ADDENDUM NO. 1

**INTERMOUNTAIN LAKE PARK NORTH LEVEL 1
REMODEL**

ADDENDUM NO. 2

Purpose for the Addendum: These changes resulted from design team clarifications and city plan review comments.

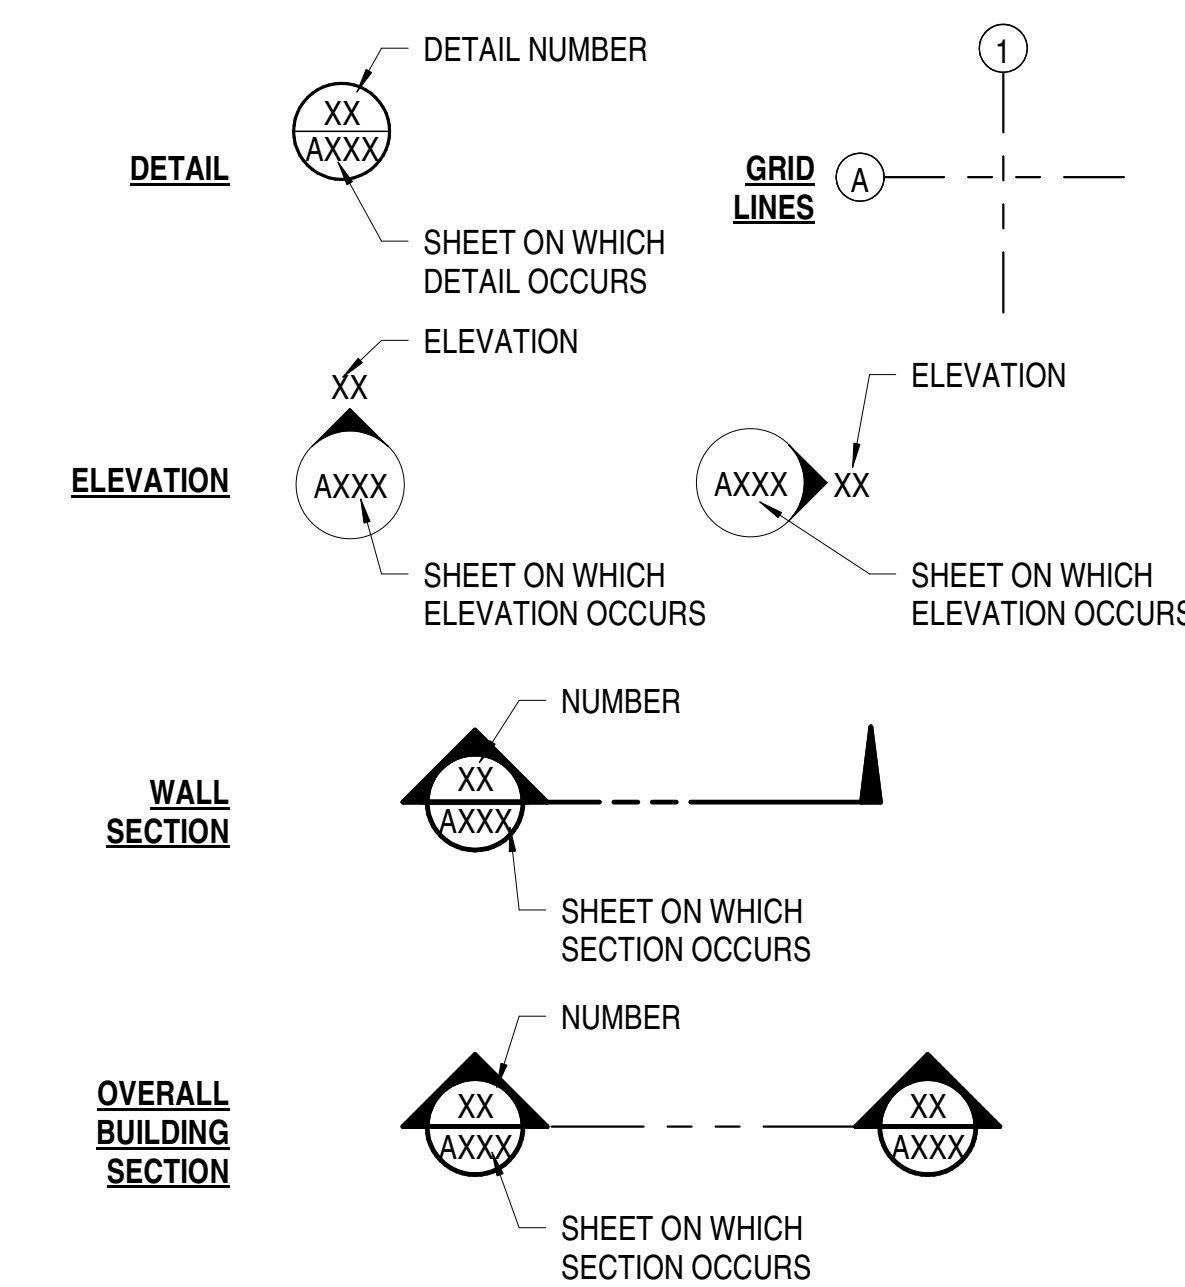
1. Update applicable code references. **See the revised G001.**
2. Provide asbestos testing prior to demolition. **The Owner will be responsible to comply with this requirement and with any potential abatement due to the testing results.**
3. Adjust plans to meet sewer district requirements. **See the Mechanical Narrative, and the revised PP101, and PP401.**

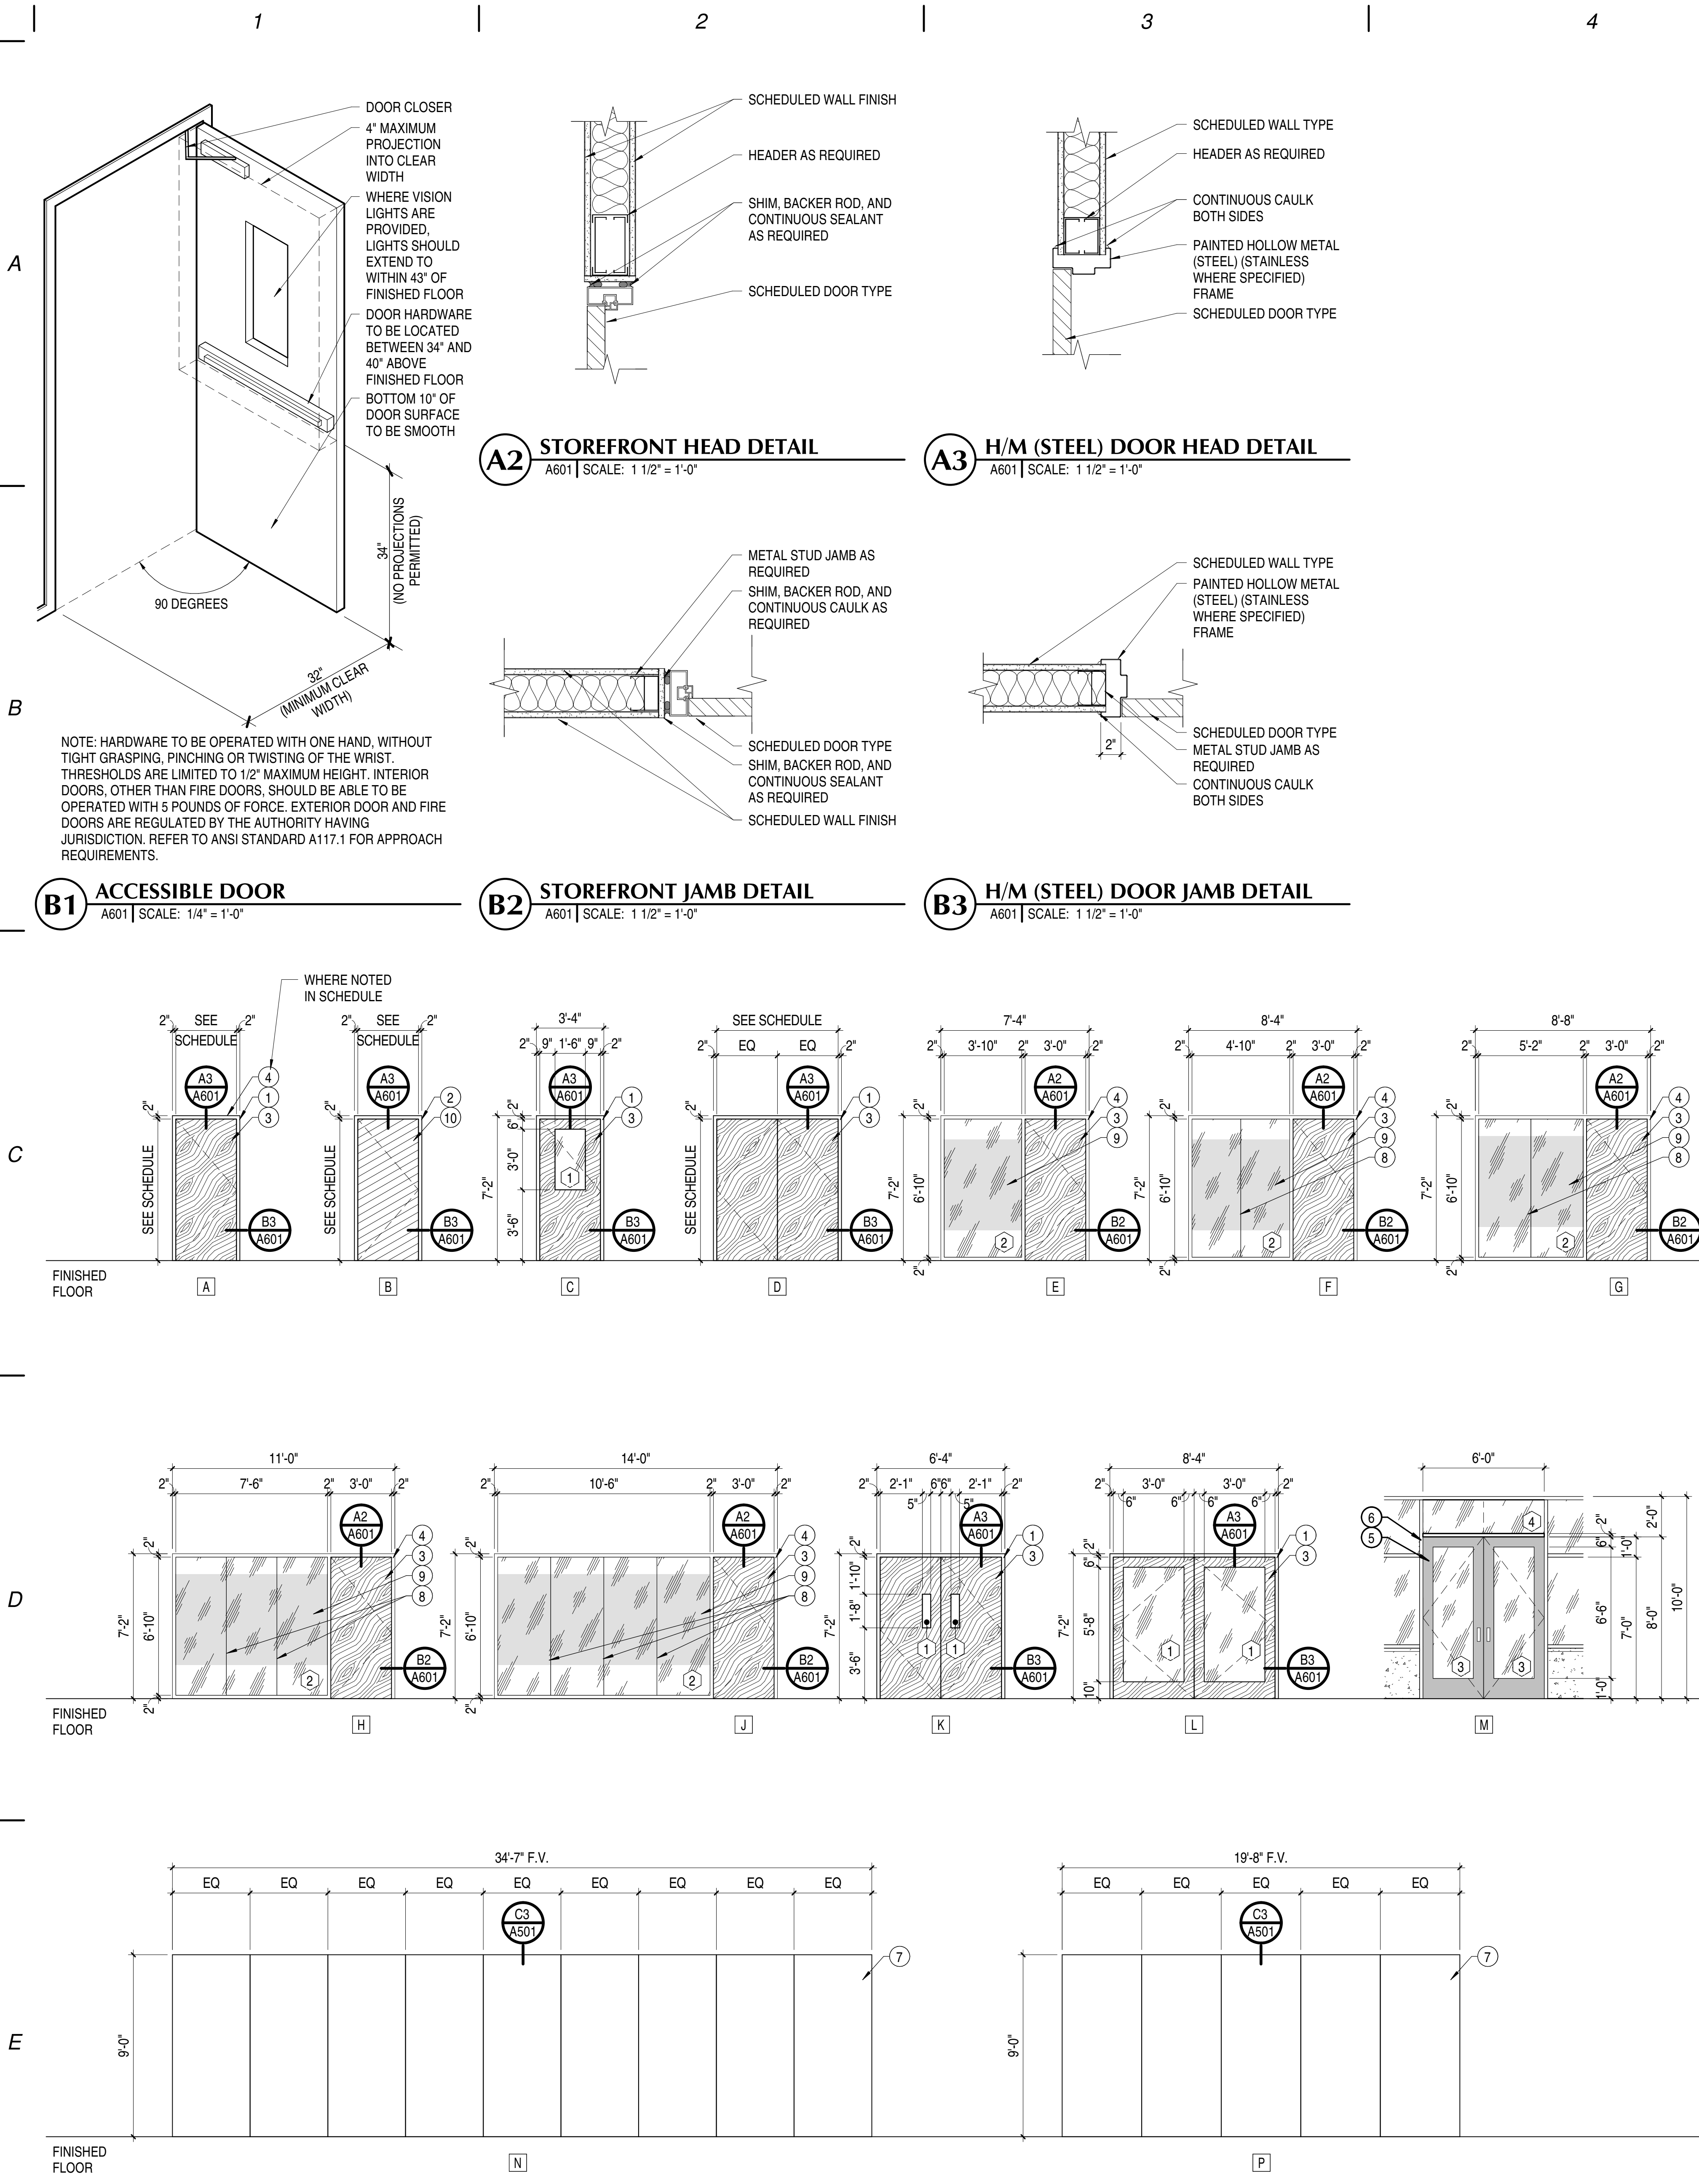
1. Some of the hardware will be provided and installed by the Owner's Access Control Company (Accent Automatics). Hardware sets have been modified to clarify scope. Other door modifications have been made as well. Please have bidders review all hardware sets. **See the revised spec section 08 7100 (hardware sets only), and the revised A601, AP101, and EP101.**

2. Glazing types have been modified for the Doors 107 and 163. **See the comments column of Door Schedule on A601.**
3. Some of the HVAC control information has been added to the plans to provide further clarification for the design intent. **See the Mechanical Narrative and the revised spec section 08 7100 (changes to hardware sets only), and the revised MH601 and MP101.**

D2 INTERIOR FINISH PLAN - LEVEL 1
 AI101 | SCALE: 1/8" = 1'-0"

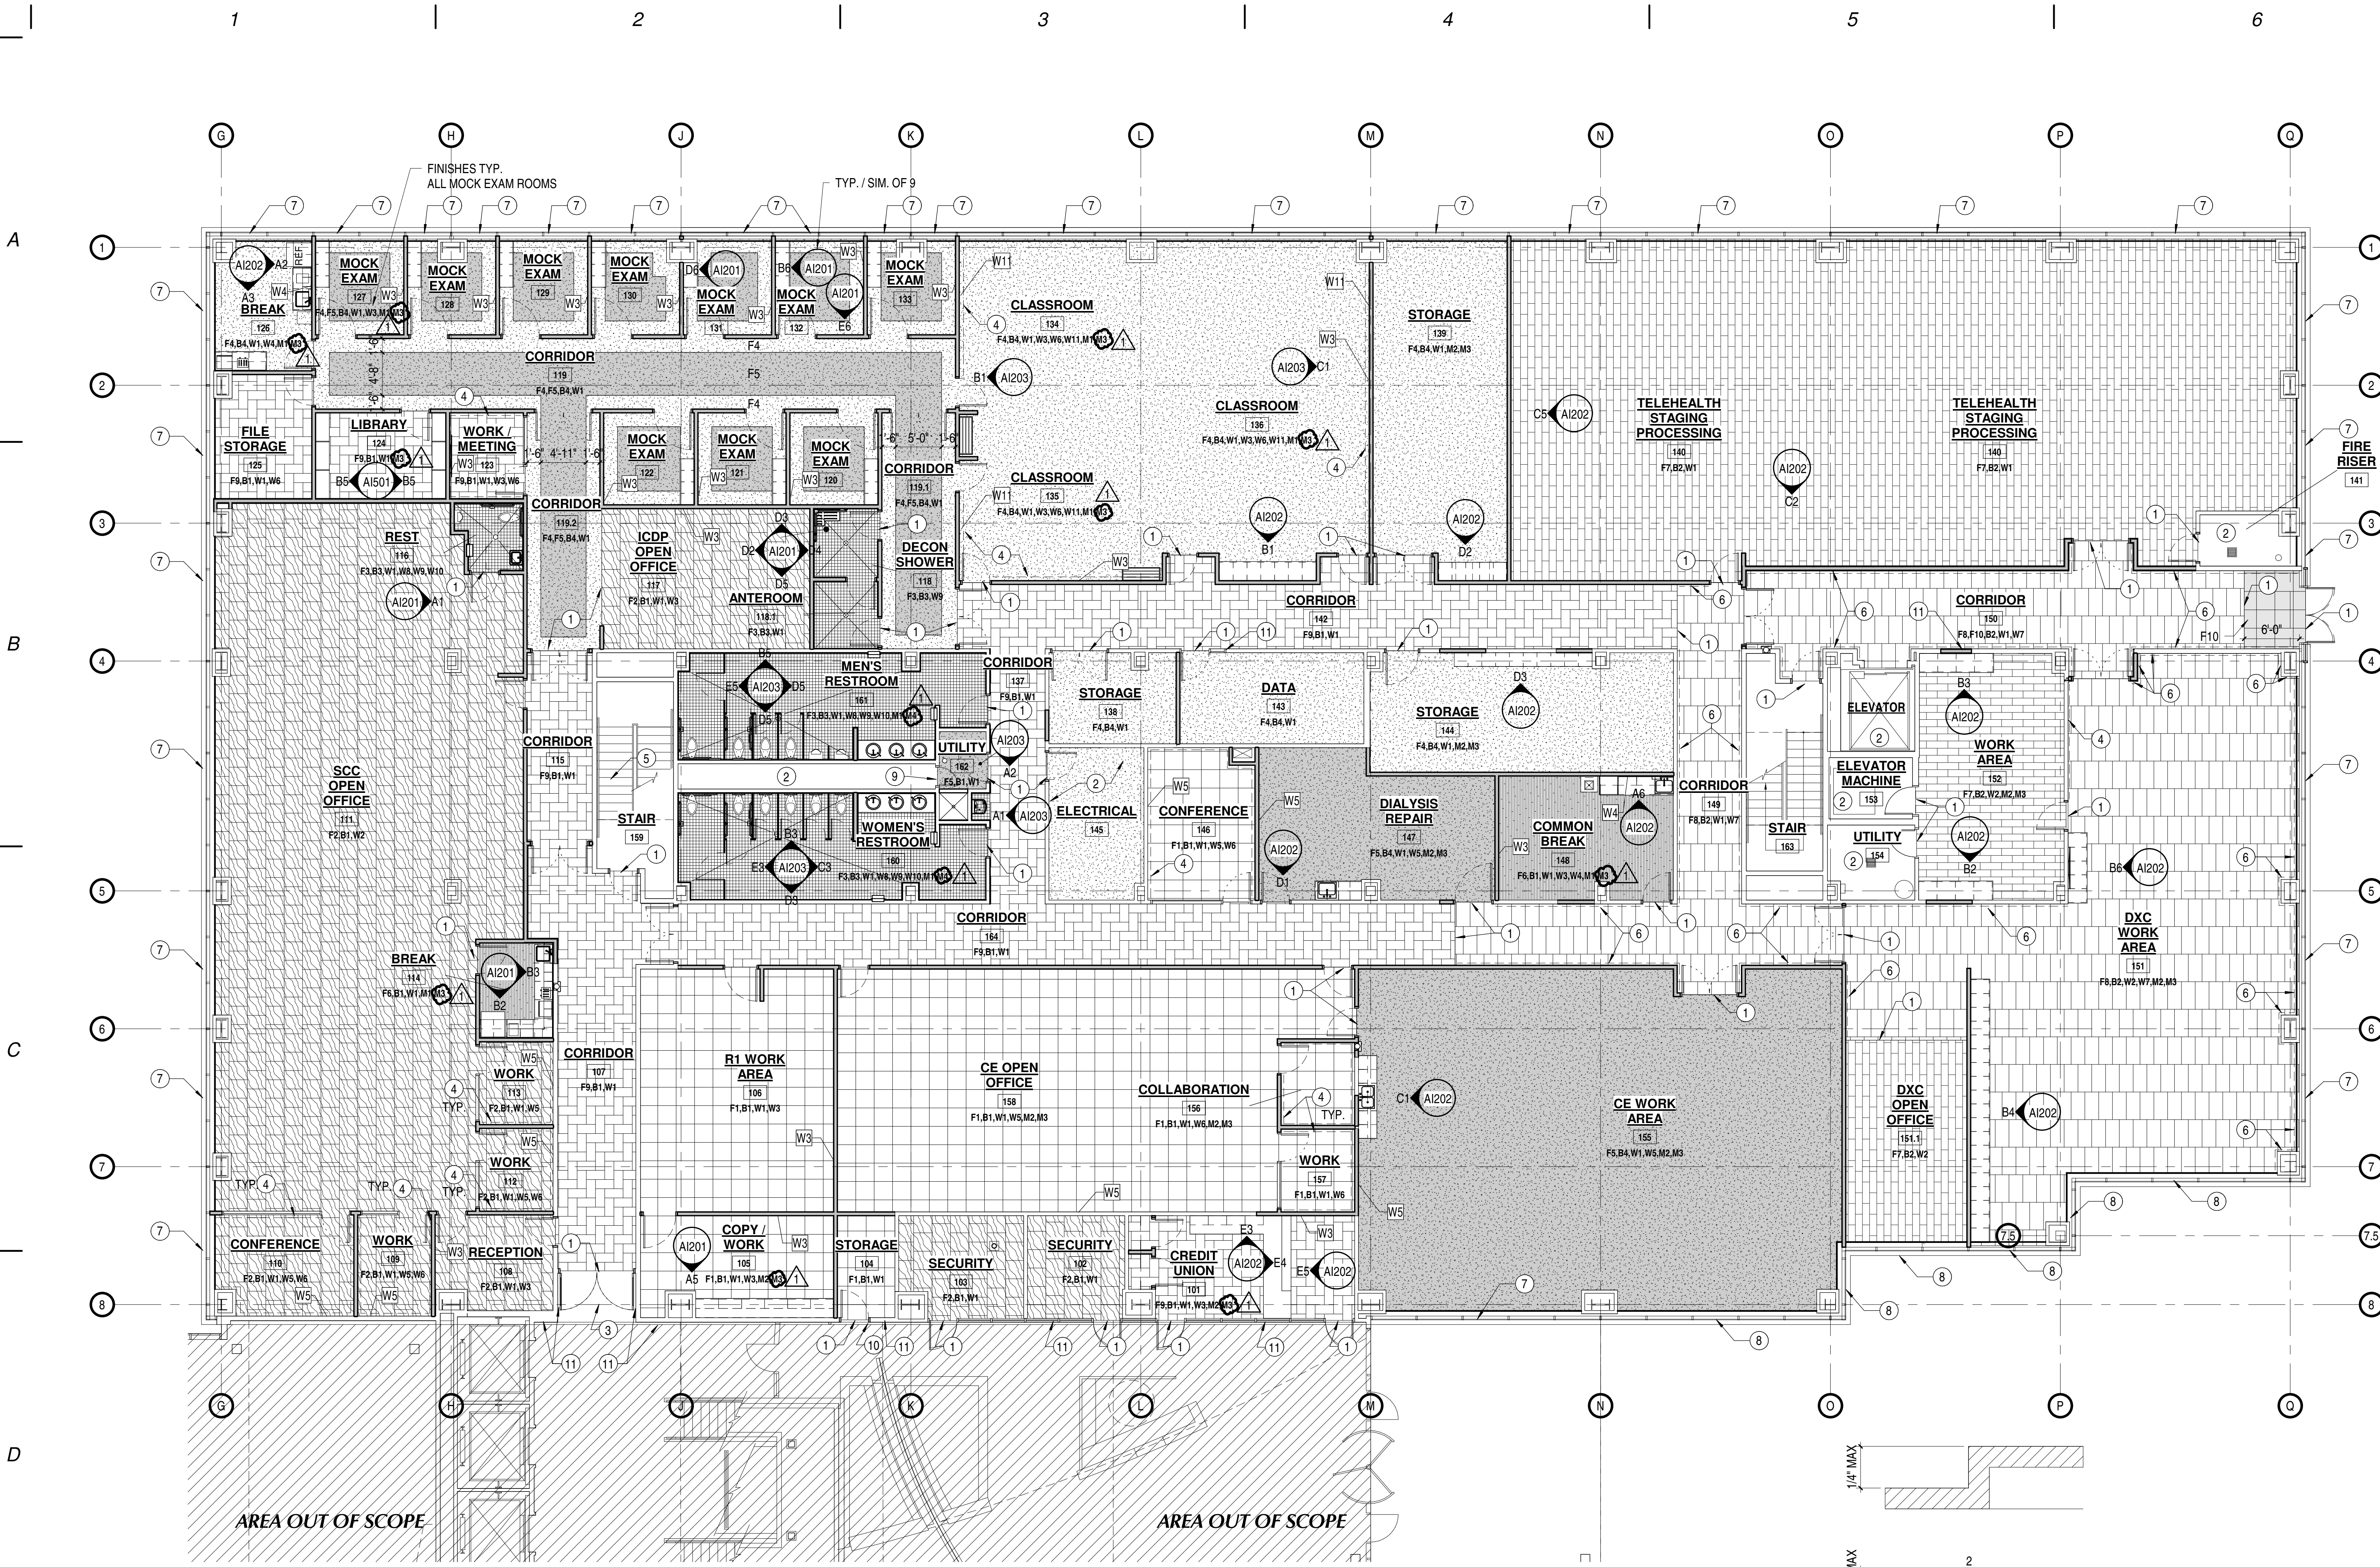
4. Some further clarification is being provided for the acoustical panels (W11) called out on AI101. Additionally, it was noted that Koroguard no longer makes the specified chair rail. We have therefore changed the specification for those products to another manufacturer, so that they all match. **See the revised AI101.**

5. Clarifications have been made to the Koroseal Acoustical Panel System. Additionally, it was noted that Koroguard no longer makes the specified chair rail. We have therefore changed the specification for those products so that they all match. **See the revised AI101.**

6. Clarification has been made regarding the painting of the steel door frames. **See the revised AI101 General Note "B".**
7. Questions have arisen regarding the Level of drywall finish. Per General Note "H", "GYPSUM BOARD WALLS AND CEILINGS SHALL HAVE A SMOOTH LEVEL 5 FINISH (EXISTING AND NEW). DRYWALL CORNERS ARE TO BE SQUARE". **All bids are to include in the base bid a Level 5 Finish.**

8. Modifications have been made to the millwork finish. The originally specified M4 finish was removed and the M5 Toilet Partitions are now designated as M4. The millwork that was designated as M4 in the finish plan is now M3. **See the revised AI101.**
9. Questions have arisen regarding the structural support for the folding partition door. **Due to the current uncertainty of how this system will be structured, and in an effort to keep all bids consistent, we have decided to have each contractor carry a \$10,000 material and labor allowance for the structural support only in the base bid. Further clarification on this item will need to be coordinated during construction.**
